Amendment to the Drawings

REMARKS

Title: COMPUTATIONALLY EFFICIENT DEMODULATION
FOR DIFFERENTIAL PHASE SHIFT KEYING
Serial No. 10/615,880 Attorney Docket No. H0004522-5601
ANNOTATED SHEET

Figure 1
(Prior Art)

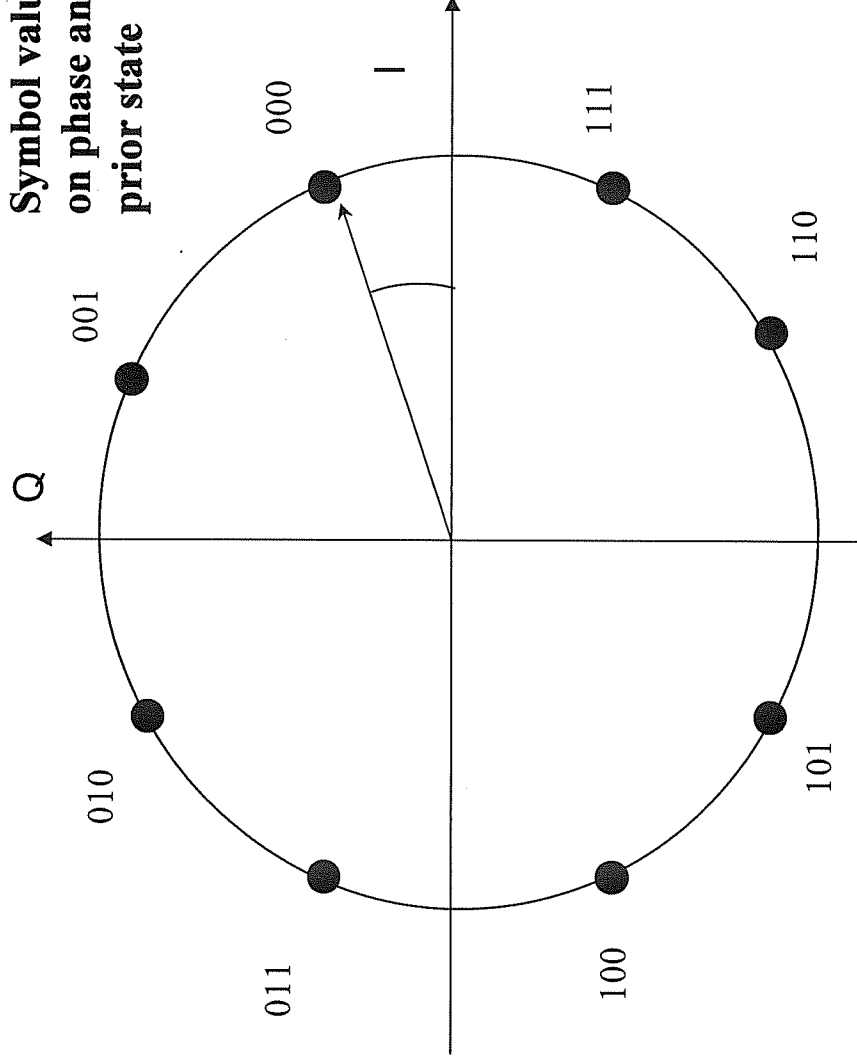
Fig. 1 – The legend “Prior Art” has been added.

Figure 2
(PRIOR ART)

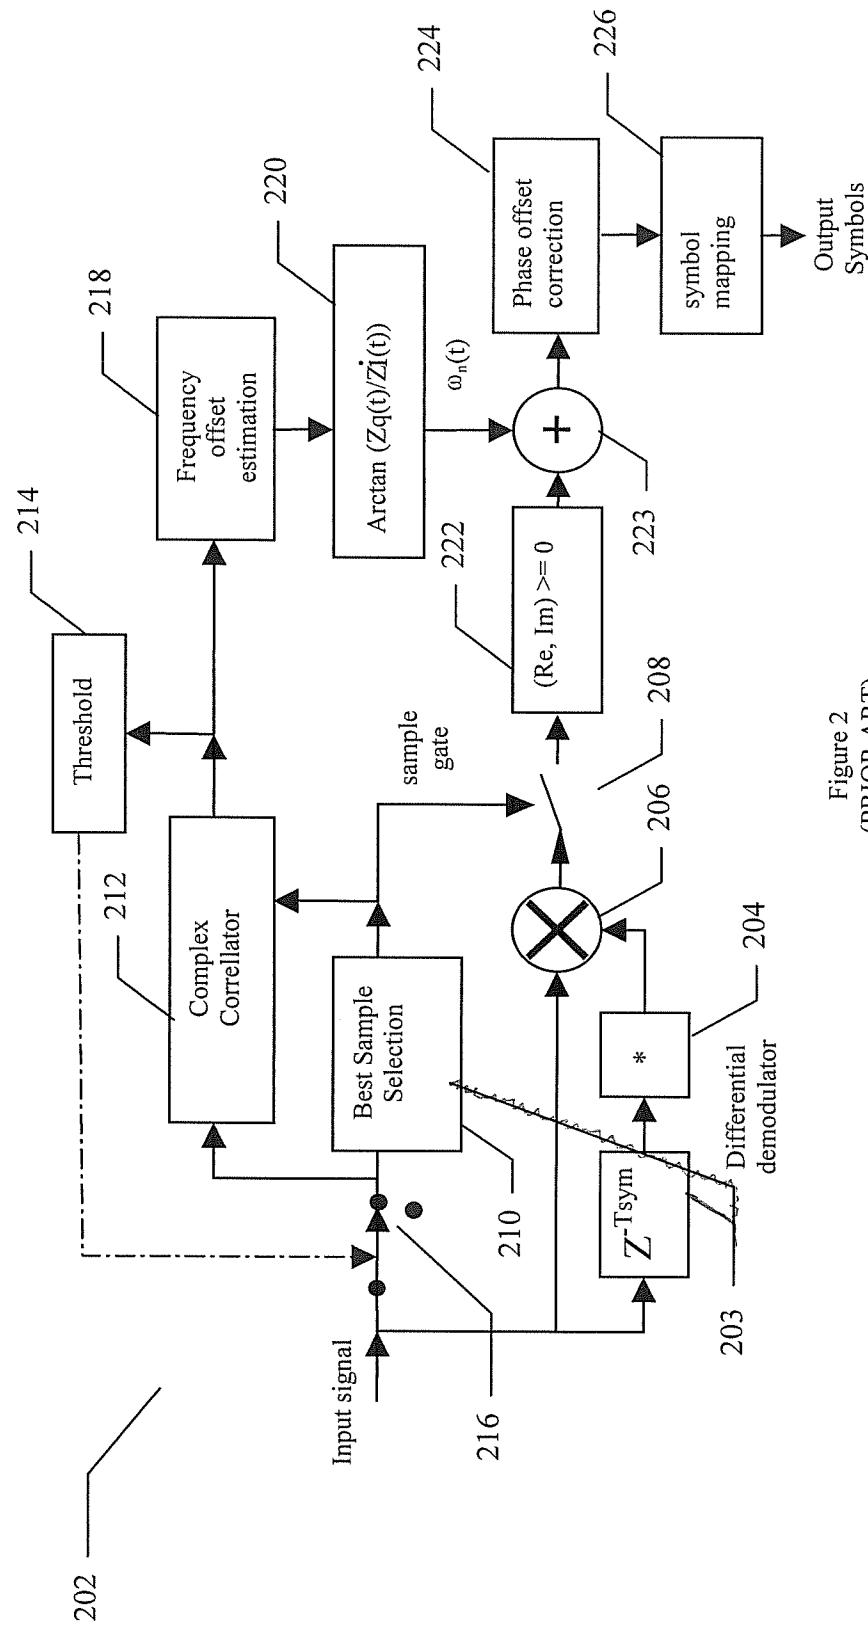
Fig. 2 – The lead line for element 203 has been correct.

Figure 3

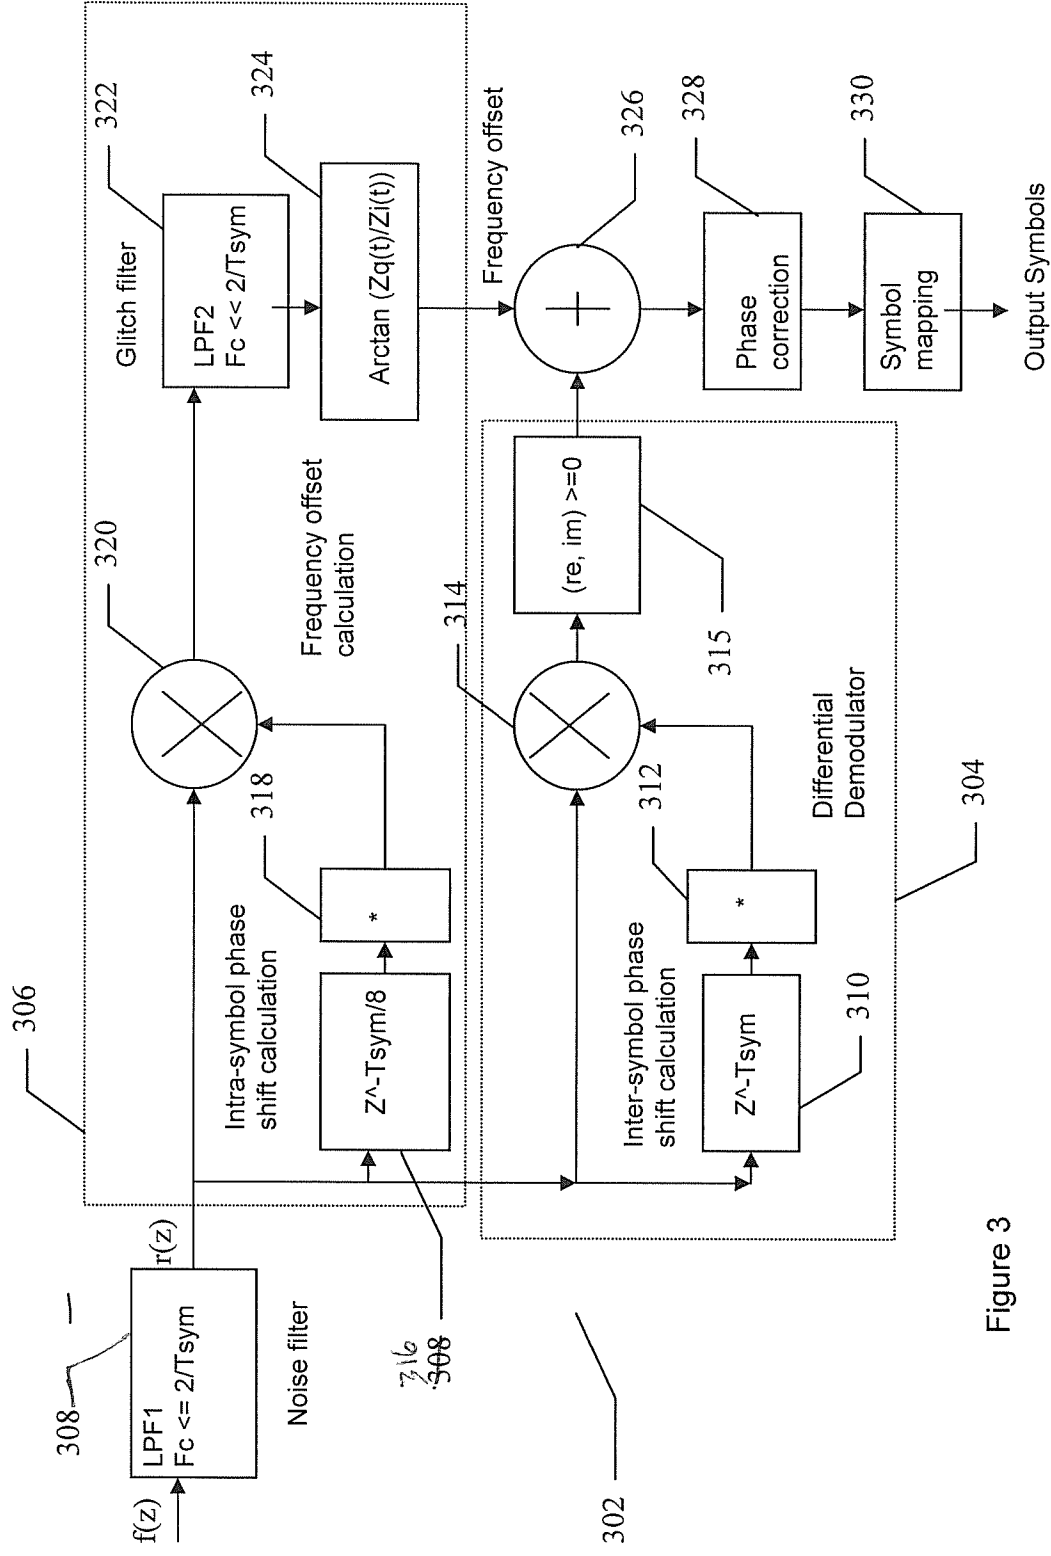
Fig. 3 – The reference numeral for delay circuit 316 in frequency offset calculator 306 has been corrected.
